Progress Report
Fourth Quarter 2008 – October 1st to December 31st
Midwest Roadside Safety Facility
Midwest State's Regional Pooled Fund Program
December 15, 2008

Pooled Fund Consulting Summary

Figure 2. KsDOT Guardrail Posts Adjacent to Slope

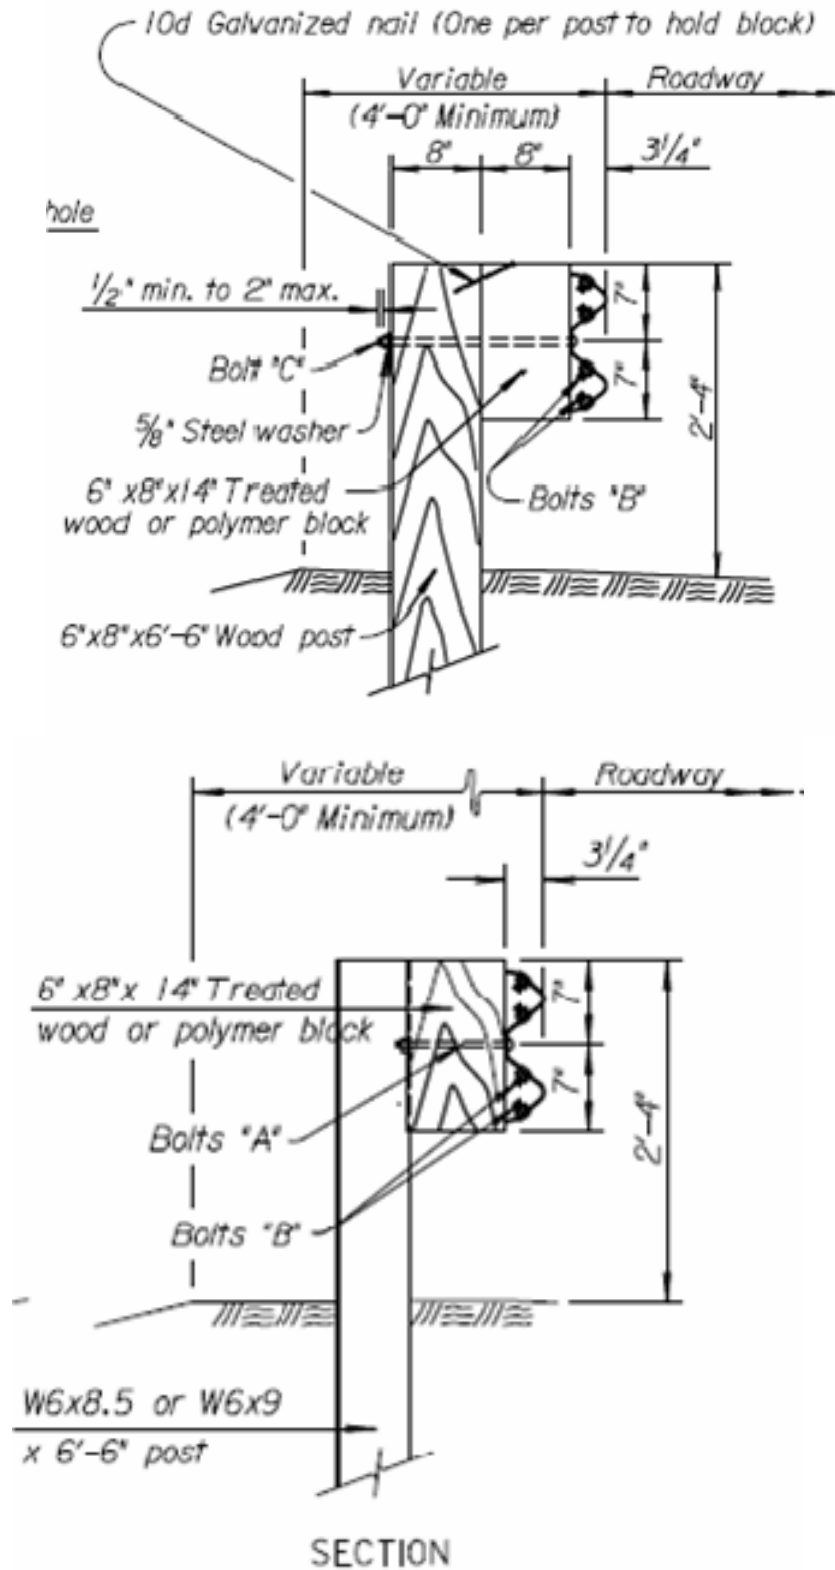
I wanted to pass a guardrail-slope question past you. KDOT uses 6"x8"x6'6" wood posts or W6x9x6'6" steel post for guardrail. Typically, we would use a 10:1 platform that is a minimum of 4' from the face of the rail to the slope break line. Below are details of our wood and steel post with the 4' minimum platform. Would it be acceptable on a guardrail site to allow a 3:1 slope graded from the back of post (no platform behind post) with our 6'6" posts at normal 6'3" post spacing or would it be preferable to use half post spacing (any nesting?) ? I recall your study grading a 2:1 slope with 7' posts on half post spacing. I believe you did not nest the rail either. Anyway, please give me your thoughts. I appreciate it!

Based on your inquiry, the KsDOT provides approximately 29" of fill behind the wood posts and 31" of fill behind the steel posts. For both KsDOT configurations, more than 2' of fill is provided behind the steel and wood posts, thus resulting in guidance that any slope could be used beyond the 24" of generally level terrain. This recommendation is based on the use of 6' long posts in standard W-beam and MGS systems. The use of 6'-6" posts would provide increased post-soil forces over those provided with the 6' long posts. In addition, the safety performance of the KsDOT W-beam guardrail systems using 6'-6" post lengths would be nearly identical for systems installed in level terrain as well as the terrain described in your email. Finally, the two guardrail systems shown below could utilize 6' post lengths instead of the current length of 6'-6" in standard installations with sufficient compacted soil fill is placed behind the posts.

Figure 5. High-Tension Cable Connection

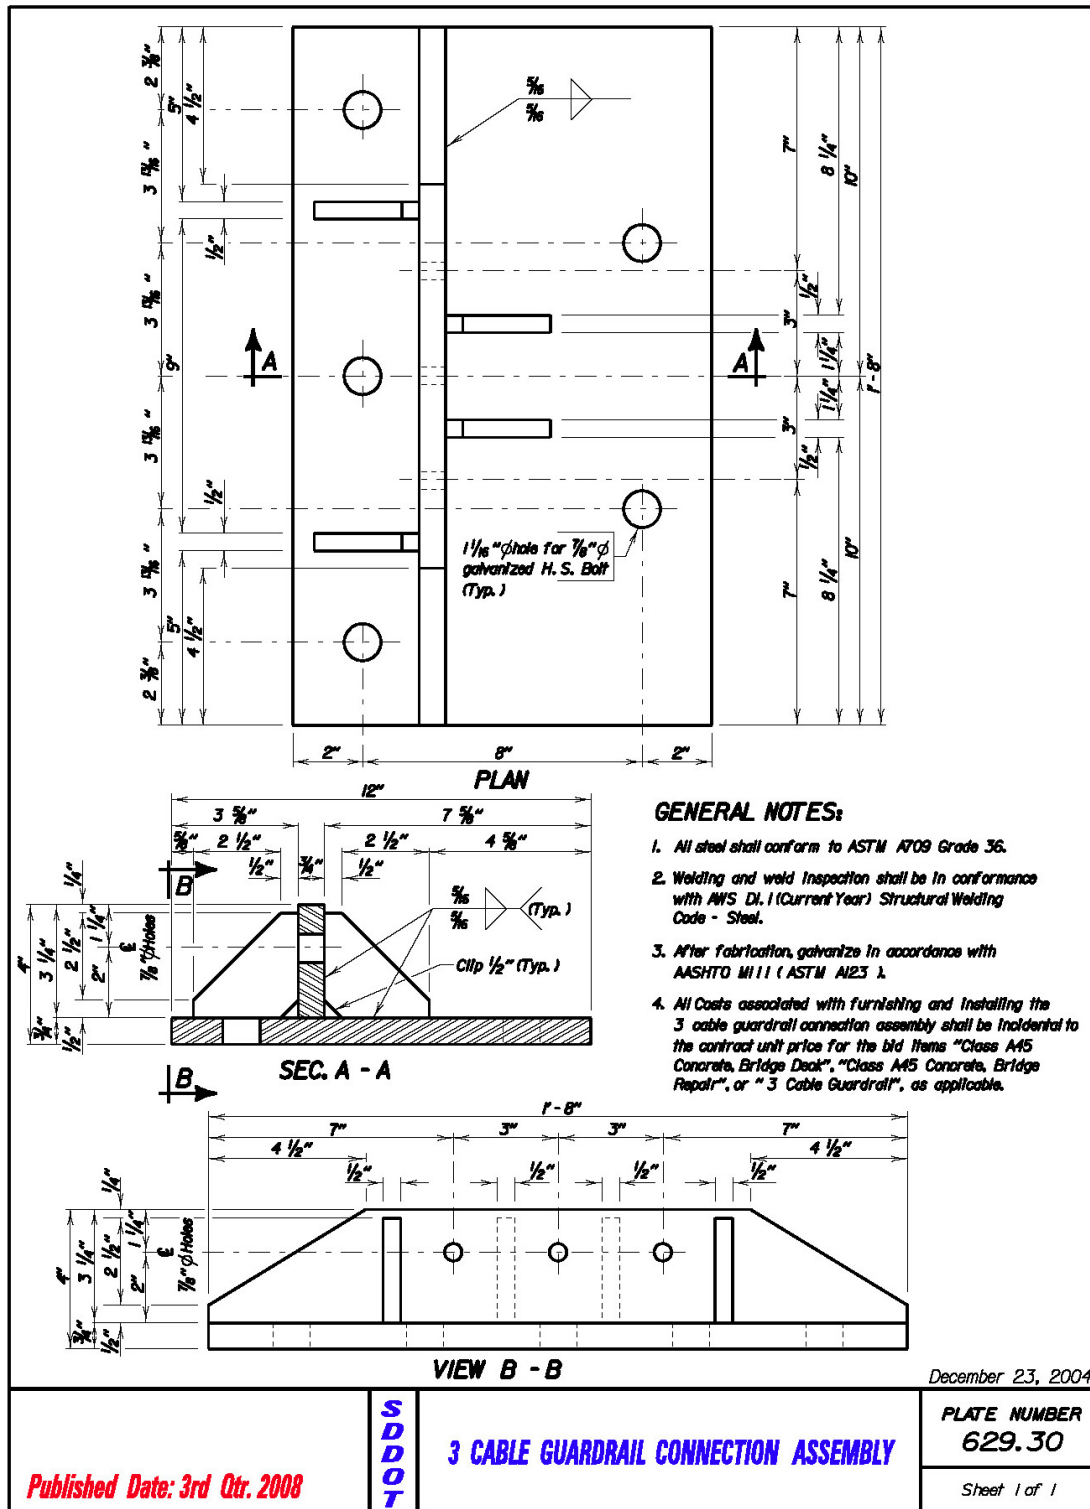
2. I have attached a drawing of a bracket used to connect high tension cable to a concrete barrier or bridge end. Our intent is to use these brackets on the trailing end of bridges, instead of a ground anchor, to provide continuous protection for errant vehicles. For continuous median installations, this bracket would be located beyond the clear zone for opposing traffic. The manufacturer has informed me that the bracket is the same one that is used on a ground anchor, and it is almost identical to a low-tension bracket used by South Dakota (detail attached), but with larger bolt holes. This cable attachment portion of the bracket would be located behind the bridge rail where it cannot be hit. However, part of the bracket is exposed on the front side of the bridge rail and could possibly be a snag point. I was hoping you could give me your opinion on this design in general. Also, I would like to know whether you feel this setup would require additional crash testing. The manufacturer has told me that since this is an anchor, and not a terminal, that crash testing is not required.

2. The cable bracket is depicted on the front face of the parapet near the downstream end. This type of bracket would appear to provide concerns for vehicle snag on the bracket and anchored cables. You noted that it would be on the back-side face even though it is shown on the front face. It would be cleaner to attach the bracket on the back side. You note that the manufacturer stated the bracket is nearly identical to the SD DOT bracket used on low-tension designs and identical to their own ground anchor for HT or LT designs? The manufacturer plans to use this on high-tension designs as part of a system. If it already has been evaluated in HT cable barrier testing, then I do not see an issue with structural capacity. If it has not, then the manufacturer would need to provide some assurance that it would also work with HT systems through calculations, components tests, full-scale test, etc. The downstream cable anchorage scenario would not likely need to be re-tested as it is a rigid barrier transitioning into a flexible barrier.

Figure 7. IaDOT Bullnose

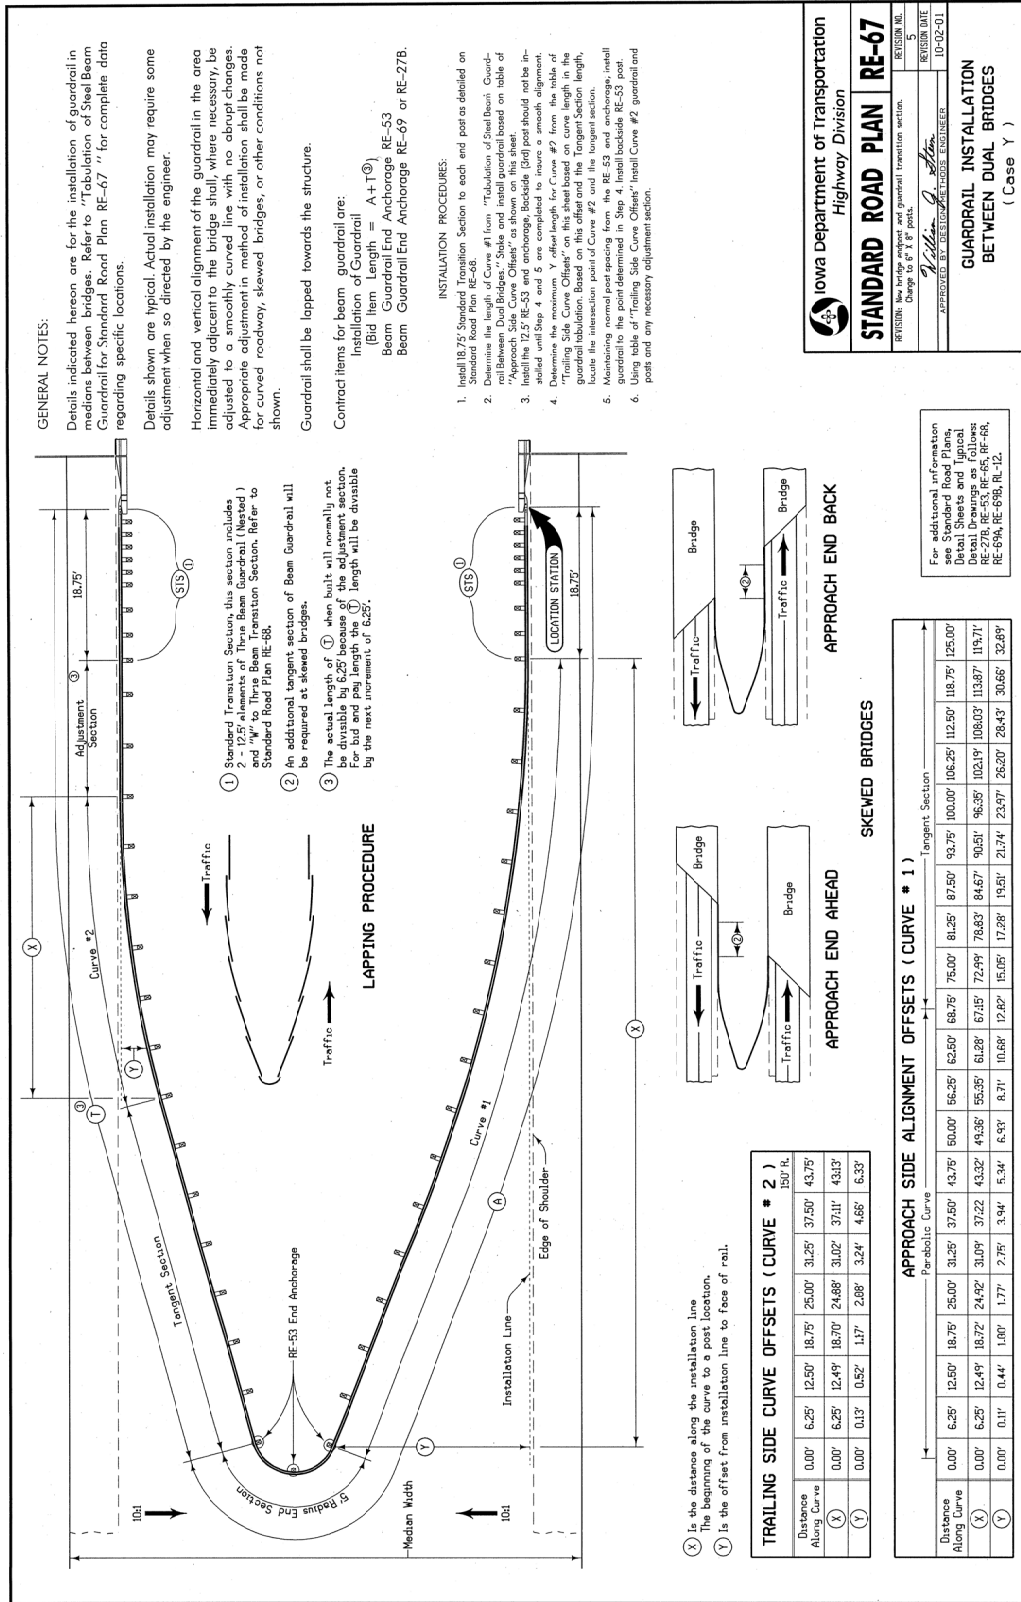
I have attached details of our W-Beam bullnose system. We would like to be able to utilize half of the existing installation (shown as the “T” distance on RE-67) when traffic is head-to-head on the side of the roadway near the top of the page. I am unsure whether we would need to leave the 5-foot radius end section attached, or if we would need to replace that with some other type of end terminal.

I have reviewed the materials that you have provided. Based on this review, I offer the following comments. First, I understand that two-way traffic will be utilizing the lanes provided at the top of the page (page RE-67), while the bridge at the bottom of the page is being replaced. As such, the hazard between the twin bridges still requires shielding. As I see it, you have two basic options.

Option 1 consists of removing the bullnose buffer end and guardrail sections that connect the bullnose barrier to the lower bridge end. Once that material is removed, a crashworthy guardrail end terminal and anchorage system would be connected to the guardrail system shown at the top of the page. The flared guardrail length would be selected such that the system provides adequate shielding of the median hazard.

Option 2 consists of removing a portion of the lower approach guardrail transition (i.e., the section connecting the bullnose guardrail to the lower bridge end). The “STS” segment, measuring approximately 18.75’ in length, could be removed to allow construction of the new bridge. Then, in the first two spans of remaining rail, an approved anchorage system could be installed such that anchorage is provided in both directions, thus simulating a rigid attachment to the bridge end. If this option is desirable, we could assist with this detail.

Figure 8. Dual Anchorage for Bullnose

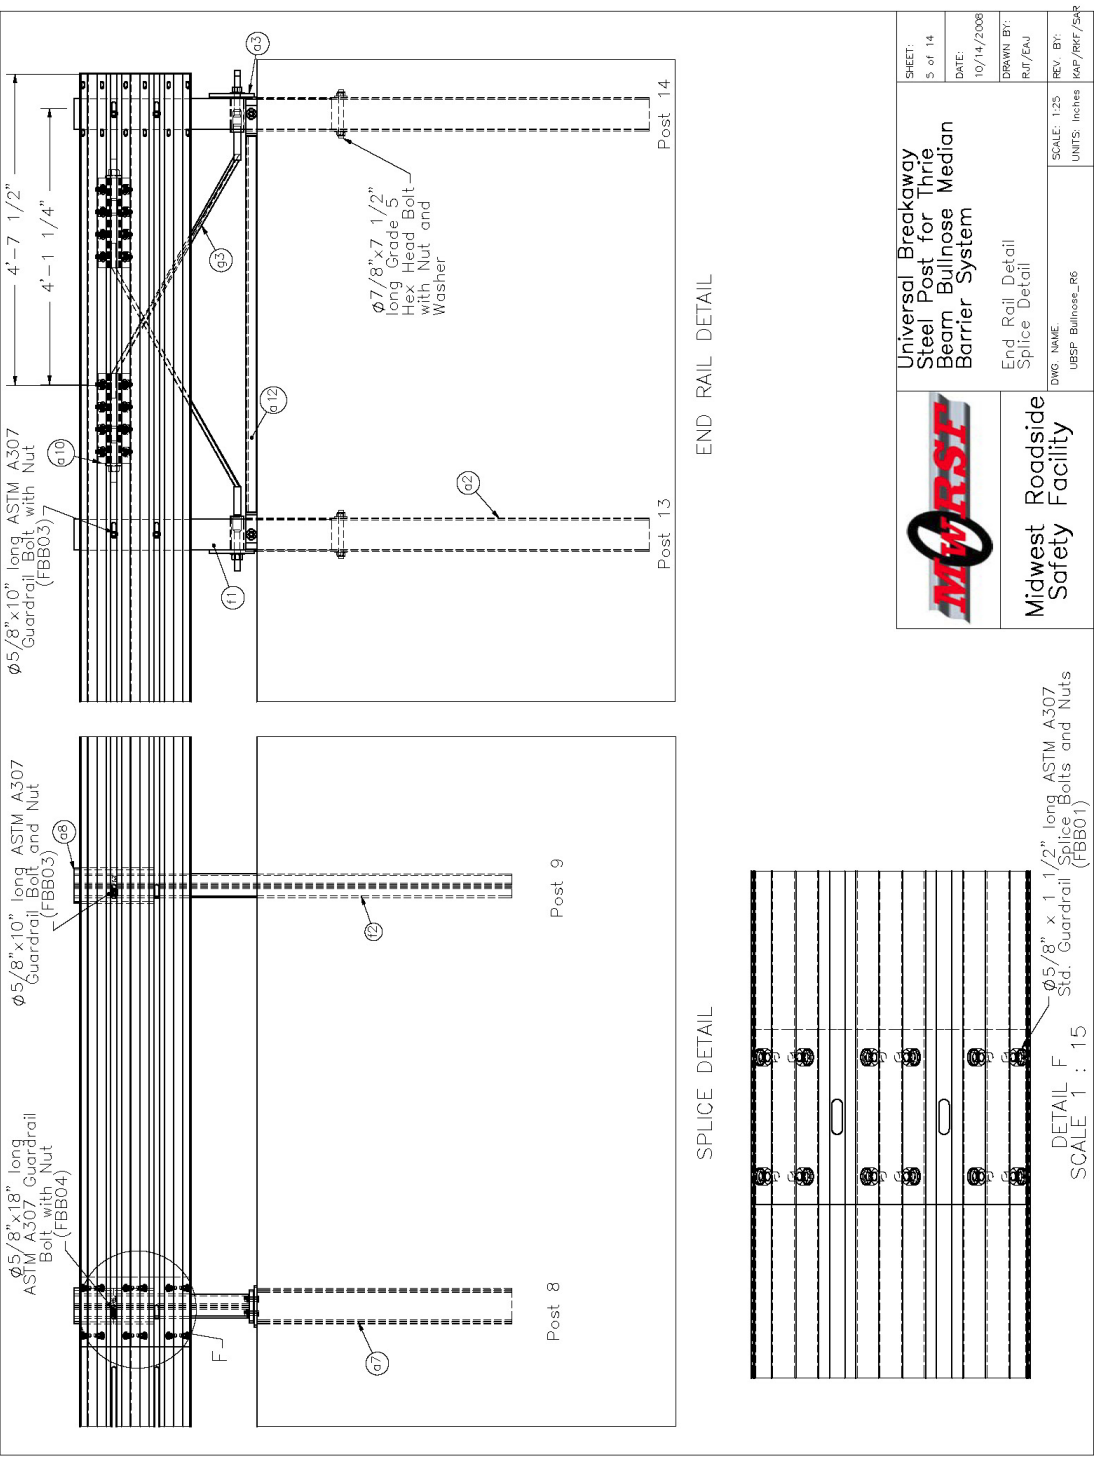
I am enclosing CAD details for a new MnDOT bullnose R&D project currently within MwRSF. For this effort, we have placed both the standard and reverse direction cable anchorages on the downstream end. In prior bullnose testing efforts, we switched the direction of the single cable anchorage from one test to another. In future testing, we will place two anchor cables on the downstream end – one in each direction.

It should be noted that this double anchorage should be used on any bullnose design that incorporates a free end that requires anchorage.

Our CAD details show the use of a 6-ft long tube without a soil plate but with a channel strut between two tubes. An alternative would be to use the shorter BCT tubes that incorporate soil plates and use the channel strut.

SECTION C-C

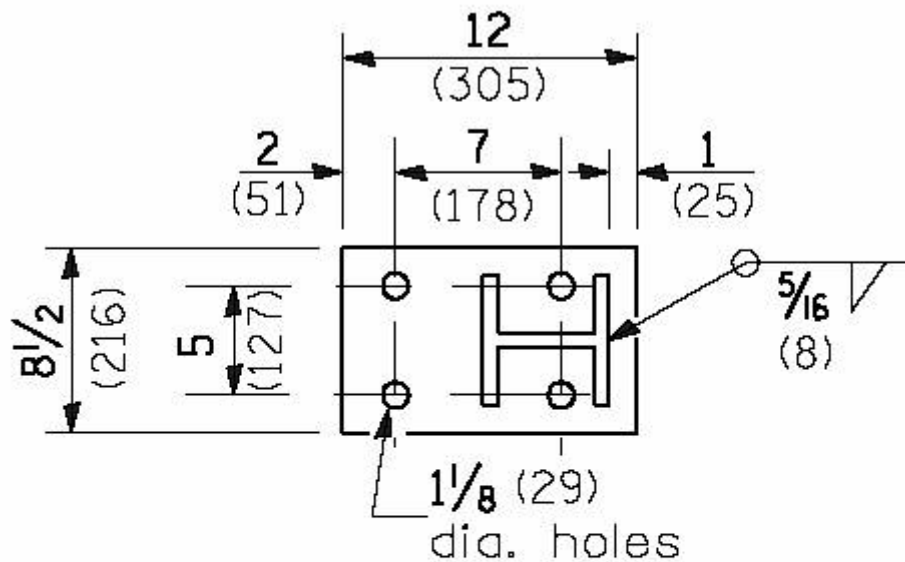
After review of the crash testing report, and discussions between our Bureaus of Design and Bridges and Structures, here is what we have come up with for a weld detail between the post and plate for this application. Does this appear appropriate?

During testing of the W-beam system attached to the top slab of a culvert, it was found that a 3 pass weld was necessary on the front and back sides of the front flange of the post. If this 3 pass weld was not completed, the post tore away from the base plate which compromised the

performance of the system. Therefore, you would need to change your weld detail on the front flange of the post to be a 5/16" 3 pass weld on the front and back sides of the front flange. It is fine to increase the weld sizes for the back flange and the web of the post and these only need to be a single pass.

We cannot recommend using only a single pass weld on the front flange unless it had been proven to work with testing. Therefore, this would require funding a bogie test in order to prove or disprove its performance capabilities.

Figure 9. C2500 Bumper Trajectory Relative to CASS Cable Height – 6:1 Slope

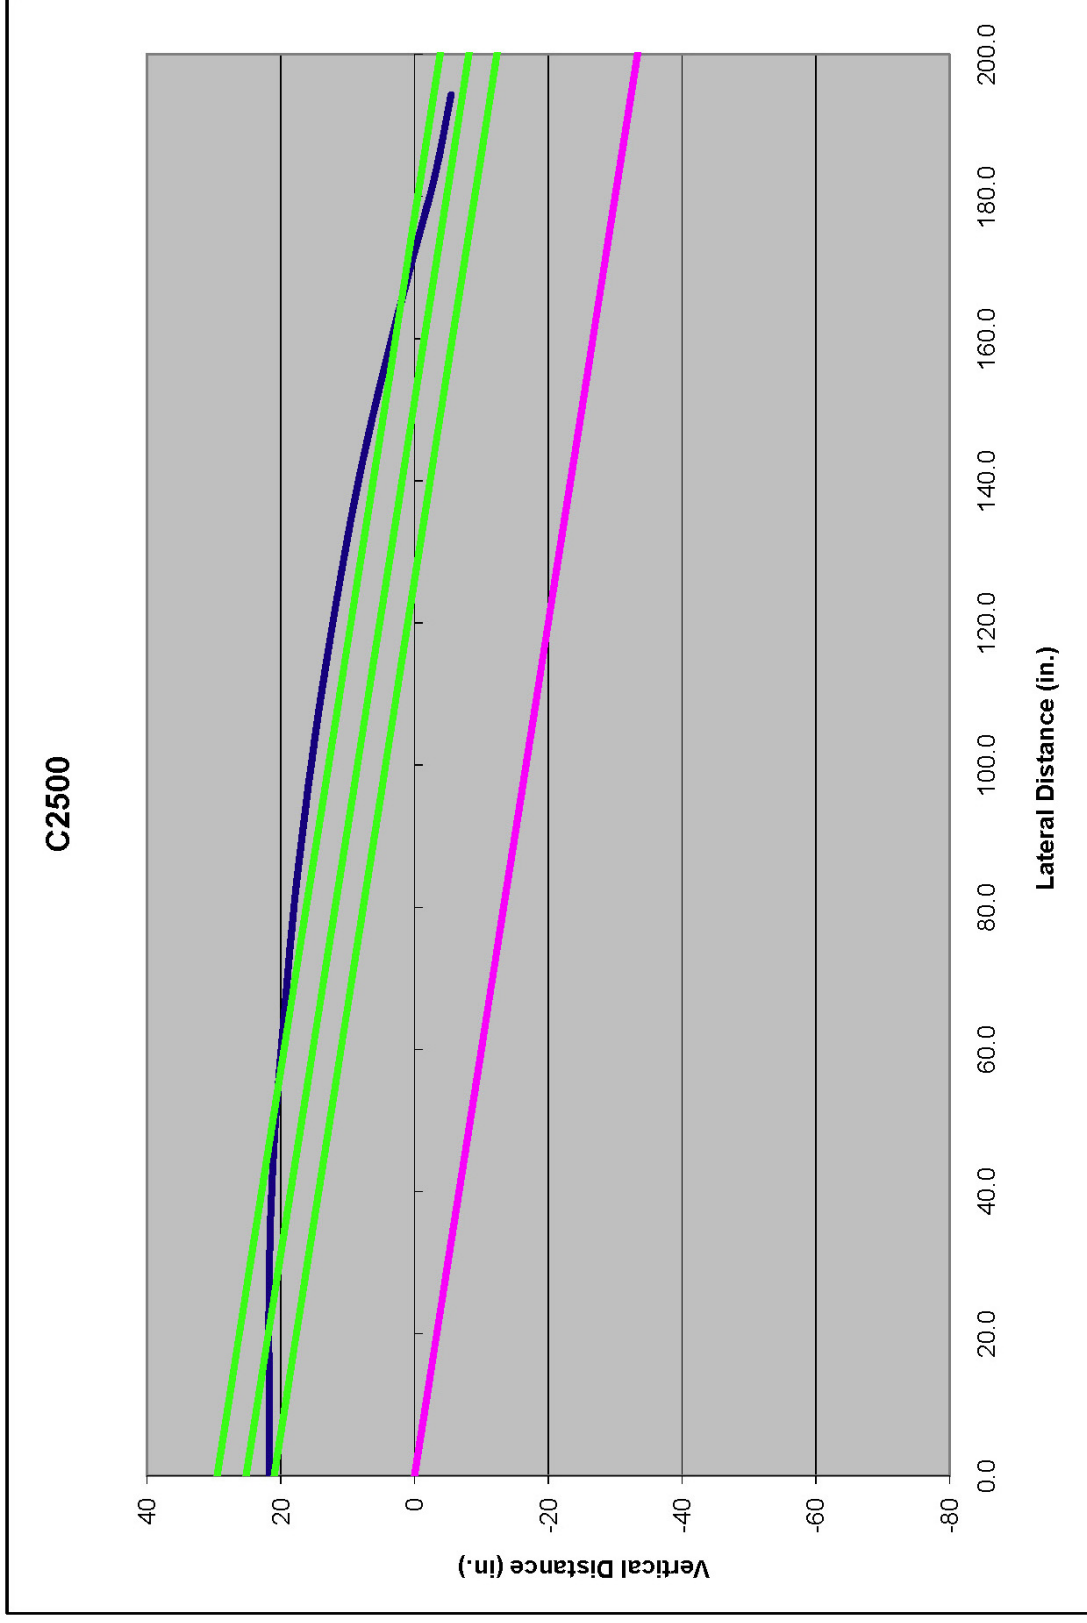
Hi Bob,
Thanks for the e-mail sent to me in April regarding cable guardrail adjacent to slopes. I had one additional concern. Since MwRSF did the testing on flat ground with the low tension cable system, would you change your recommendation if the cable was placed on 1V:6H or 1V:8H slopes in front of and up to 4 ft. behind the cable before starting on a 1V:2H fill slope. It would seem the vehicle would strike the barrier higher, so it may be necessary to constrain deflection even more.
-Bill

1. We have concerns with placement of the CASS on a 1:6H approach slope adjacent to a steep slope. This concern is based on effective capture of the vehicle by the CASS system. Previous testing was conducted on 30" high, low-tension cable barrier placed on a 1:6H slope with a 6 ft offset from the edge of shoulder. Two tests were conducted. The first was a test (3569-5) of a 1974 Plymouth sedan that weighed 4500 lbs and impacted the barrier at 59.6 mph and an angle of 24.75 degrees. The second test (3569-6) was a test of a 1974 Chevy Vega that weighed 2250 lbs and impacted the barrier at 58.4 mph and an angle of 17.25 degrees. Both of these tests showed safe redirection of the vehicle. However, the sedan and small car vehicles in this testing had bumper heights of approximately 18". Typical bumper heights for the 2000P and 2270P vehicles are around 26". Thus, there is concern that the capture and redirection of the vehicles observed in these tests would not be as likely with the higher bumper heights of the current test vehicles and vehicle fleet. The RDG recommendations for approach slopes are based on this testing, but do not take into account the higher bumper heights and CG heights of the current vehicle fleet. The reference for this testing is given below.

2. No testing was available with cable barrier on 1:8H slopes. However, I did look at our bumper trajectory relative to the CASS system for an 1:8H slope. See the attached chart. In the case of the 1:8H slope, you can see that the bumper trajectory analysis indicated that there is an improved likelihood of vehicle capture as the bumper does not exceed the height of the top cable. This would indicate potential for capture and redirection. When

using the CASS on an 1:8H slope adjacent to a steep slope, we would still recommend that you use the 4 ft offset from the cable barrier to the steep slope and also use the reduced CASS post spacing of 3 m.
